RESOLUTION NO. 22-278

A RESOLUTION OF THE CITY COMMISSION OF THE CITY OF KEY WEST (CITY) APPROVING A CHANGE ORDER IN THE AMOUNT OF \$40,446.34 FOR ADDITIONAL WORK NECESSARY FOR INSTALLATION OF THE VFD FOR EFFLUENT PUMP NO. 1, UNDER THE CONTRACT AWARDED TO D.N. HIGGINS, INC. IN RESOLUTION 20-048; AUTHORIZING ANY NECESSARY BUDGET TRANSFERS AND AMENDMENTS; AUTHORIZING THE CITY MANAGER TO EXECUTE NECESSARY DOCUMENTS UPON ADVICE AND CONSENT OF THE CITY ATTORNEY; PROVIDING FOR AN EFFECTIVE DATE

Subject: Approve change order proposal from D.N. Higgins, Inc. for the install of the effluent pump no. 1 VFD at the Richard A. Heyman Environmental Protection Facility.

Key West VFD Replacement

DATE	BY	APPROVAL
05/02/19	JN	DESIGN REVIEW
		FOR MANUFACTURING
		AS SHIPPED
		AS COMMISSIONED

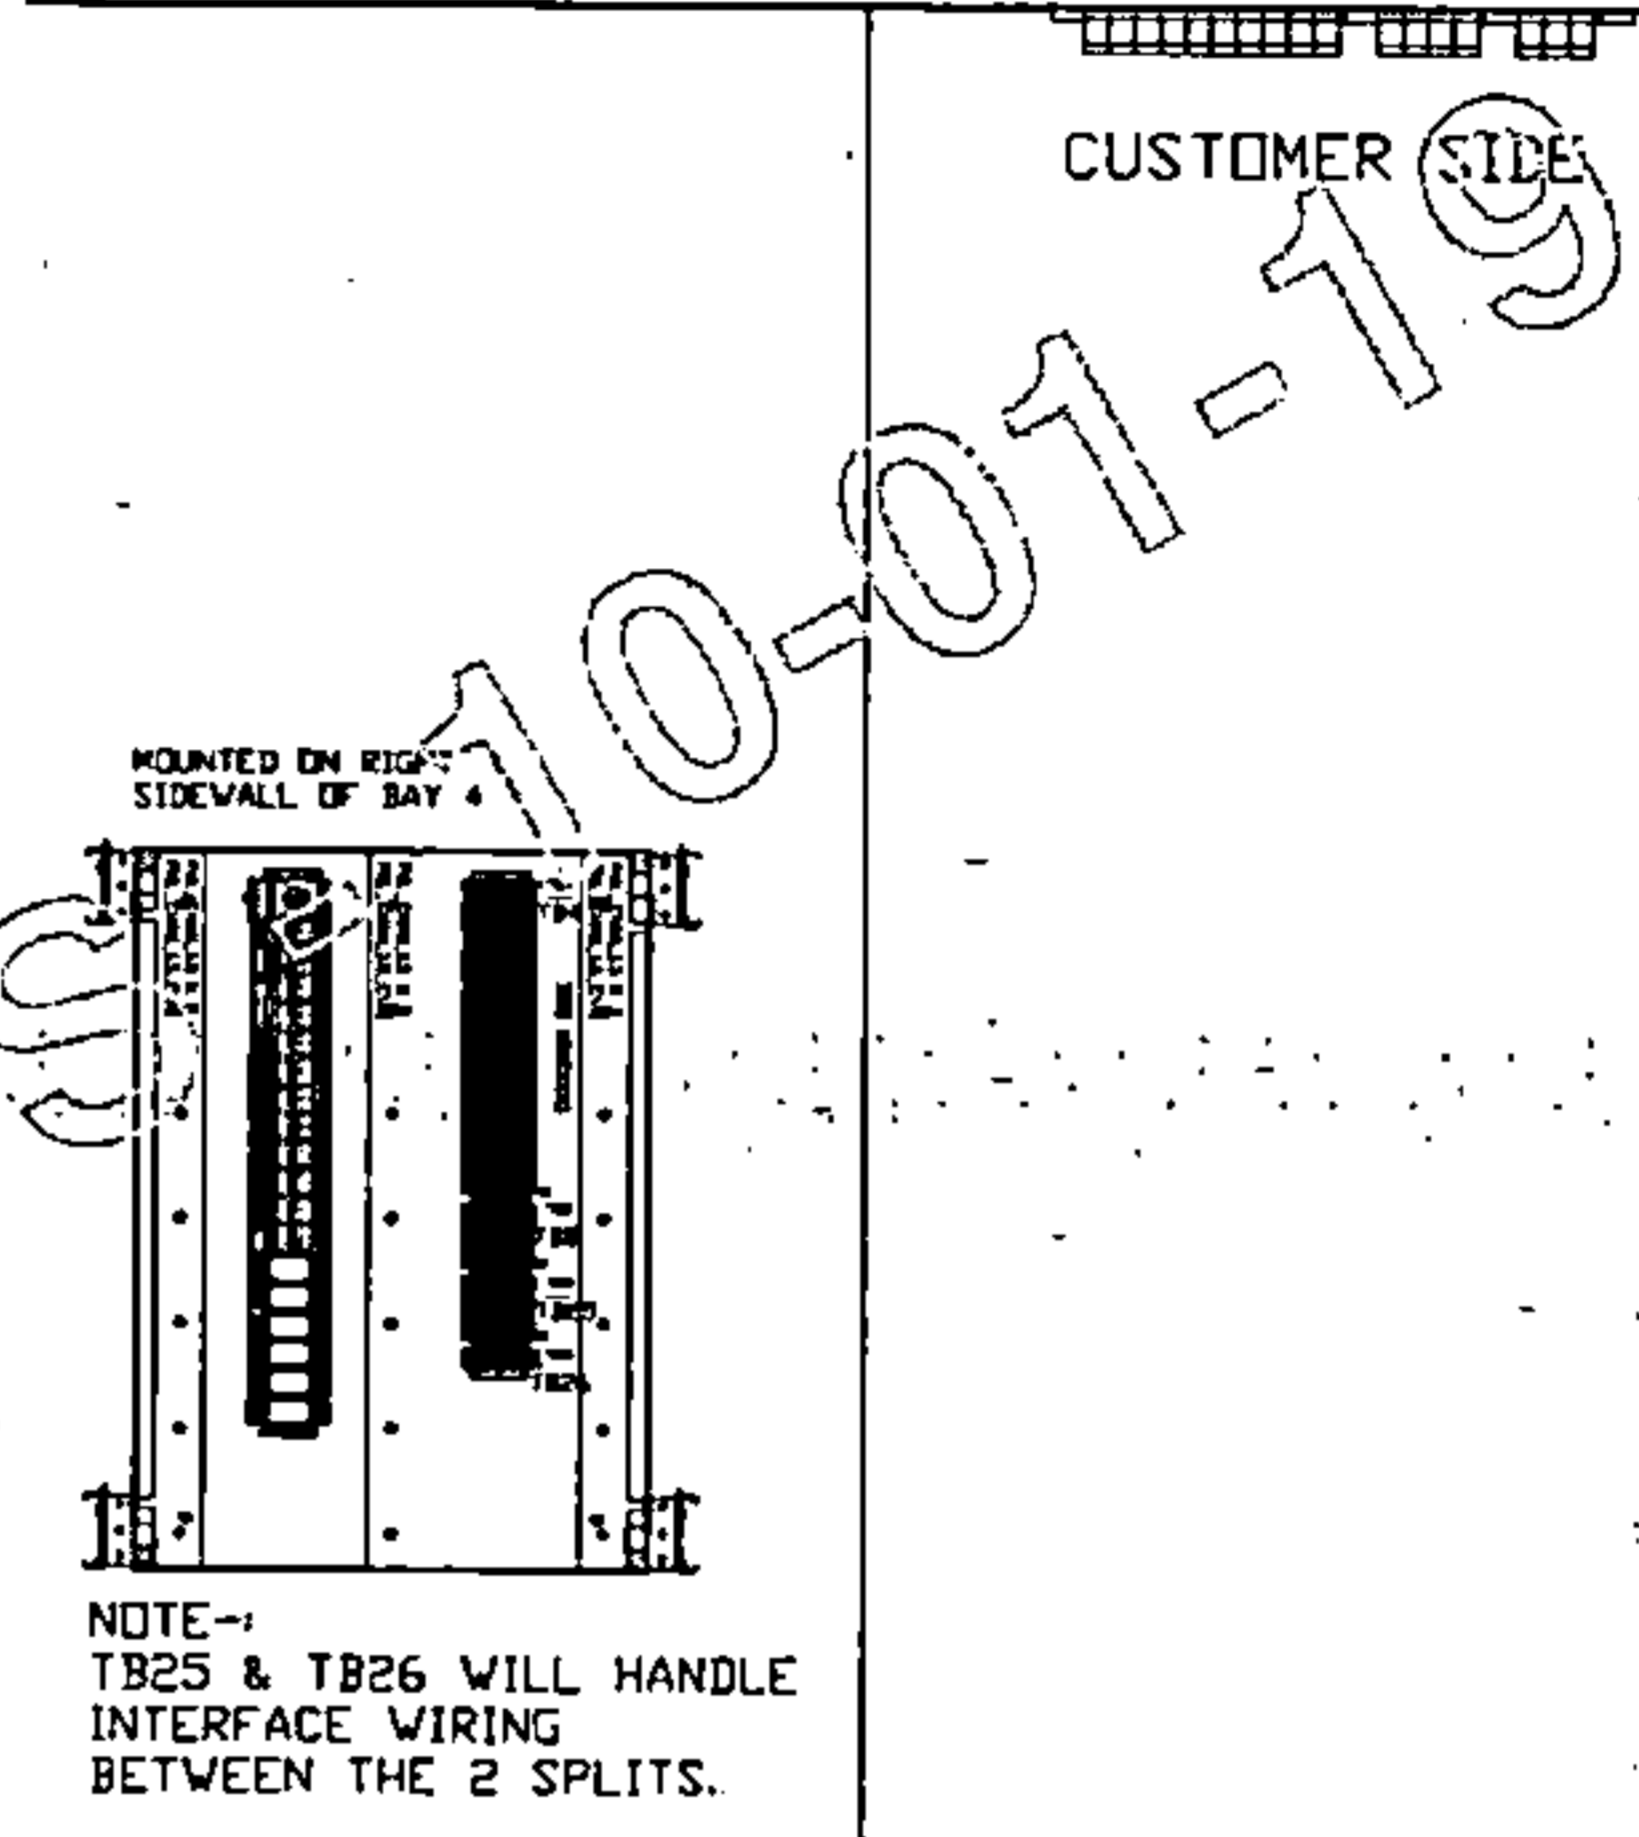
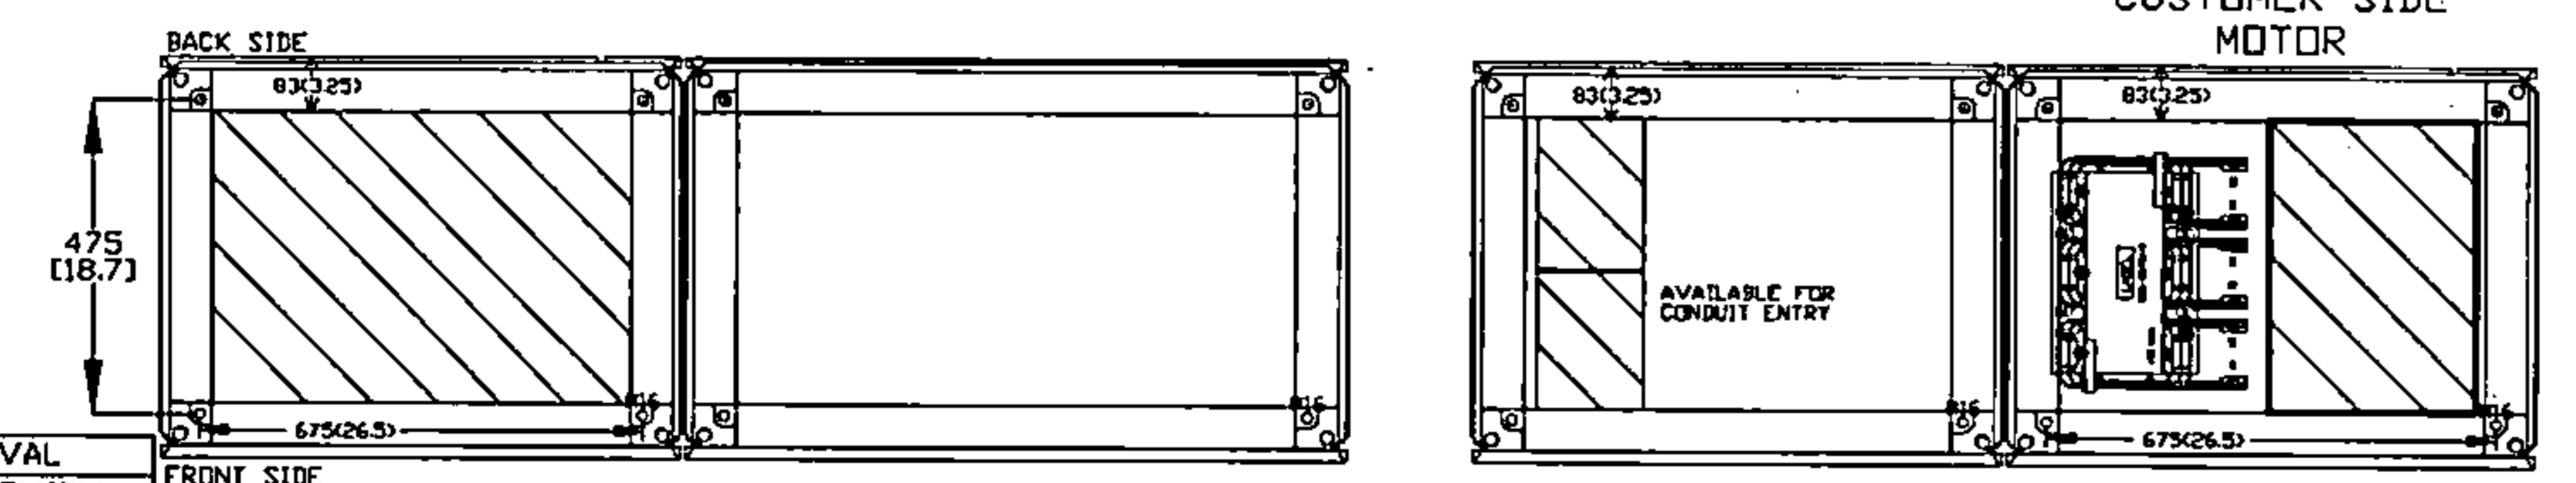
- 3) The conduit arrangement above the existing VFD will not fit in the new VFD window. See pic#4
 - a. Solution, cut the conduit close to the ceiling and install grounding bushing and free wire to the new VFD window. (as done previously) We will have to install "C" condilets to accommodate pulling wire back. See pic#5

Existing conduit layout will not fit into new conduit window

Cut existing
conduit and
install grnd
bushing then
free wire to new
VFD, as done
previously

Install "C"
Condilet

Install
Compression
Male Adapter

Mechanically
Cut Coupling
